BUILDING CODE OF AUSTRALIA AND ACCESSIBILITY COMPLIANCE ASSESSMENT REPORT

ALTERATION AND ADDITION TO A PUB

23-27 THE CORSO, MANLY

REPORT NO. ► 11784 Rev 4.0

Ground Floor

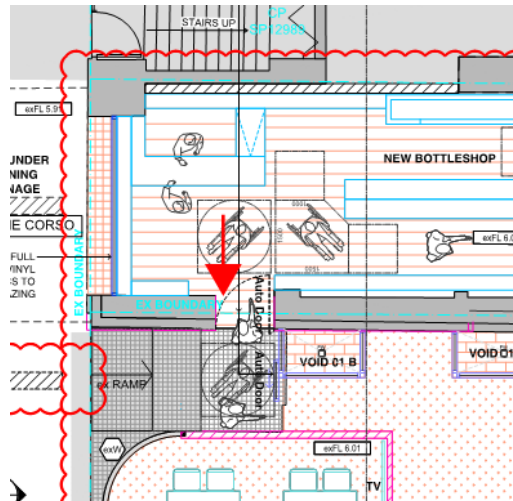
- **Ground Floor - The doorway serving the "New Bottleshop" is not provided with circulation space at the doorway in accordance with Figure 31(h), which does not comply with 13.3 of AS 1428.1-2009.**

This can be addressed by a Performance Solution.

Figure 1: Current locations of boundaries (fire source features).

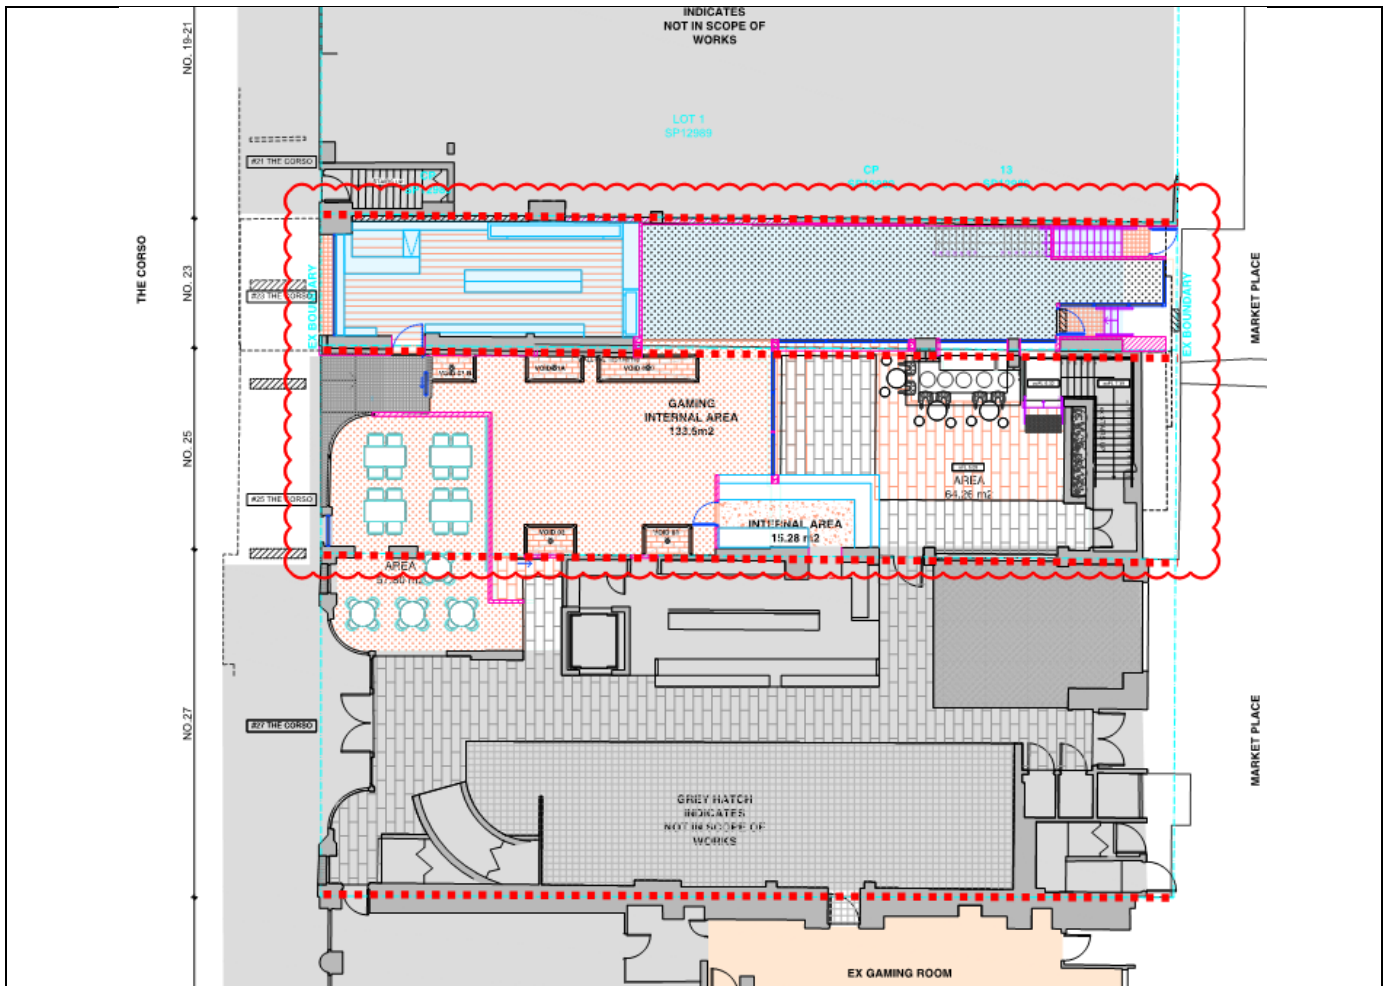
The potential *fire source features* to be considered for this building are the external wall of another building on the allotment which is not a Class 10 building, the side or rear of the allotment boundary or the far side of the road.

In this instance the boundaries (*fire source features*) are located within the building as highlighted by red dashed line marked up below.

It is recommended the allotments are amalgamated so that *fire source features* no longer exist within the building and fire separation provision of BCA Clause C1.1 & C3.2 can be determined DTS compliant.

Ground Floor

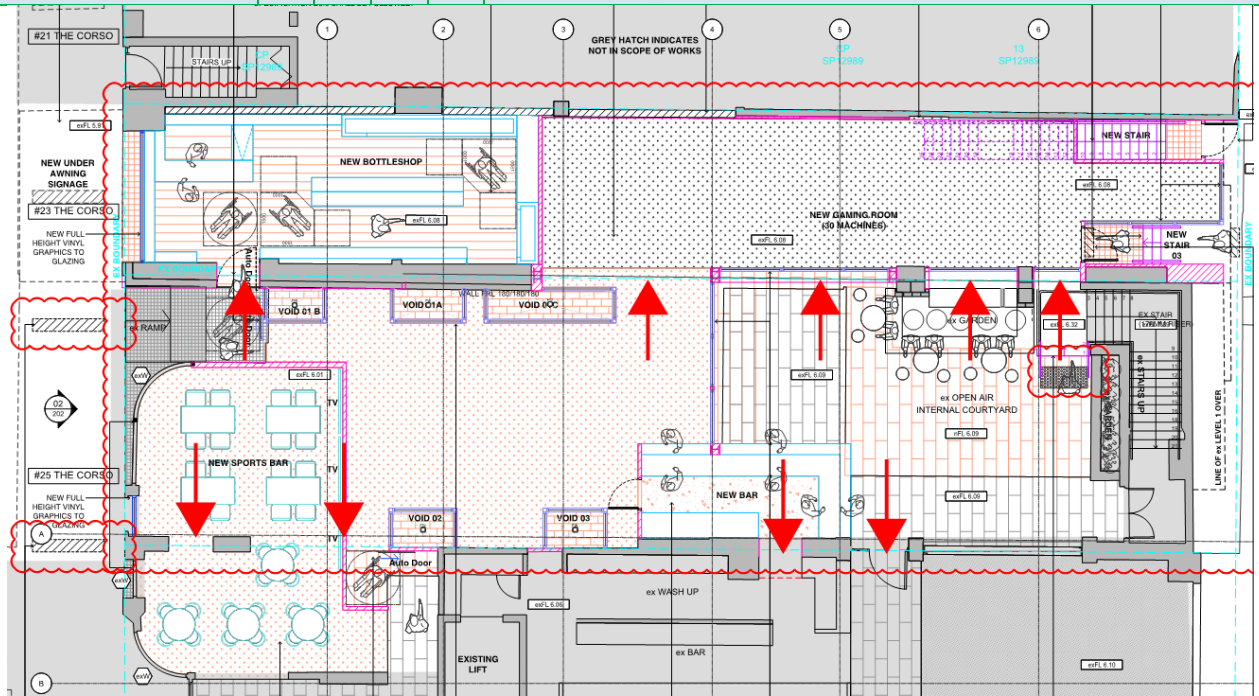
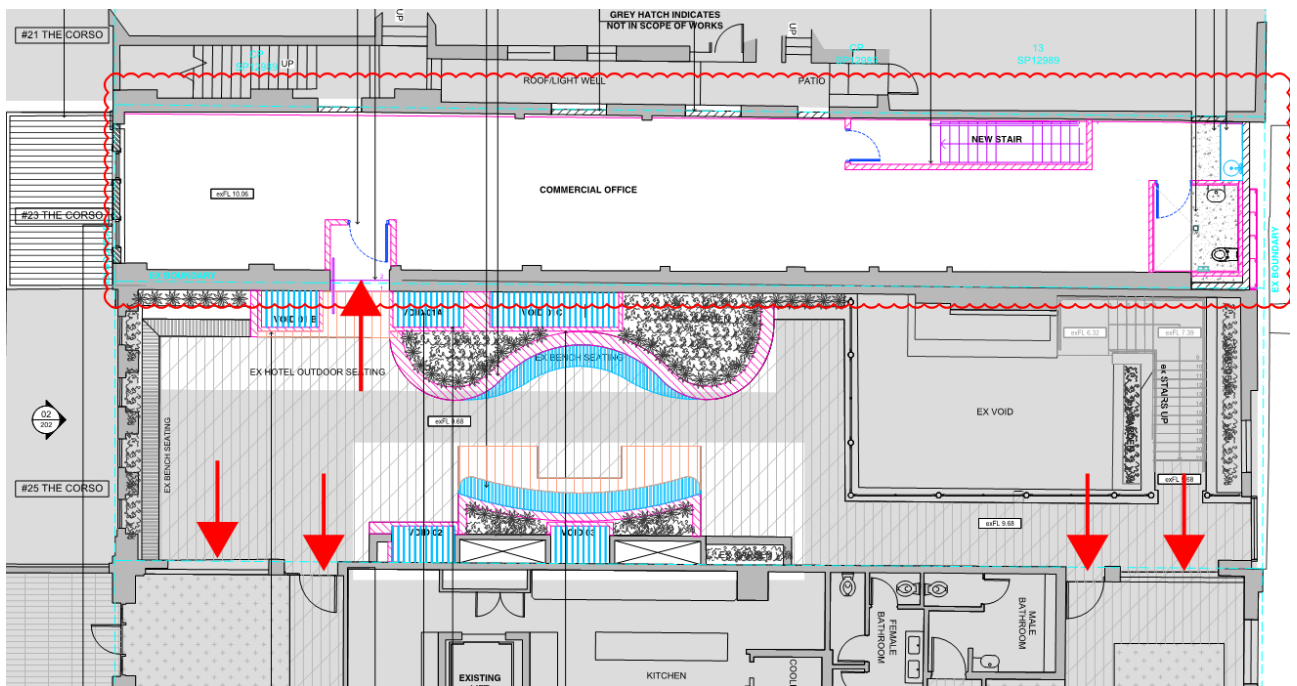
C3.2 Protection of openings in external walls		X			<ul style="list-style-type: none"> (a) Openings in an external wall that is required to have an FRL must be protected in accordance with C3.4: <ul style="list-style-type: none"> (i) if the distance between the opening and the fire-source feature is less than 3 m from a side or rear boundary; or (ii) less than 6 m from the far boundary of a road, river, lake or the like adjoining the allotment, if not located in a storey at or near ground level; or (iii) less than 6 m from another building on the allotment that is not Class 10; <p>If wall wetting sprinklers are to be used they are to be located externally.</p> (b) if required to be protected under (a), not occupy more than 1/3 of the area of the external wall of the storey in which it is located unless they are in a Class 9b building used as an open spectator stand. <p><u>DTS non-compliance</u></p> <p>The following existing and proposed openings in the walls at the allotment boundary are not protected in accordance with BCA Clause C3.4.</p> <p><i>It is recommended this is addressed by a Fire Engineered Performance Solution.</i></p>

Figure 1: Identifying the principal pedestrian entrance.

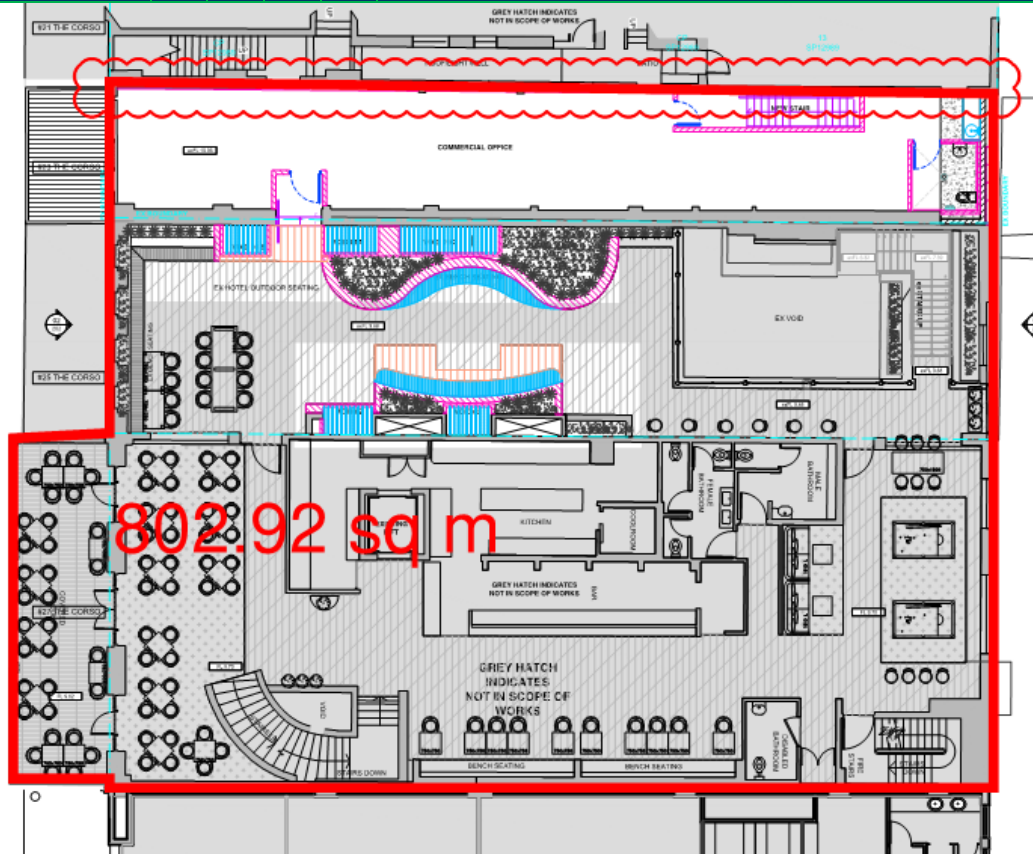
D3.3 Parts of the building required to be accessible	X	In a building required to be accessible— <ul style="list-style-type: none"> (a) every ramp and stairway, except for ramps and stairways in areas exempted by D3.4, must comply with— <ul style="list-style-type: none"> (i) for a ramp, except a fire-isolated ramp, clause 10 of AS 1428.1; and (ii) for a stairway, except a fire-isolated stairway, clause 11 of AS 1428.1; and (iii) for a fire-isolated stairway, clause 11.1(f) and (g) of AS 1428.1; and (a) every passenger lift must comply with E3.6; and (b) accessways must have— <ul style="list-style-type: none"> (i) passing spaces complying with AS 1428.1 at maximum 20 m intervals on those parts of an accessway where a direct line of sight is not available; and (ii) turning spaces complying with AS 1428.1— <ul style="list-style-type: none"> (A) within 2 m of the end of accessways where it is not possible to continue travelling along the accessway; and (B) at maximum 20 m intervals along the accessway; and (c) an intersection of accessways satisfies the spatial requirements for a passing and turning space; and (d) a passing space may serve as a turning space; and (e) a ramp complying with AS 1428.1 or a passenger lift need not be provided to serve a storey or level other than the entrance storey in a Class 5, 6, 7b or 8 building—
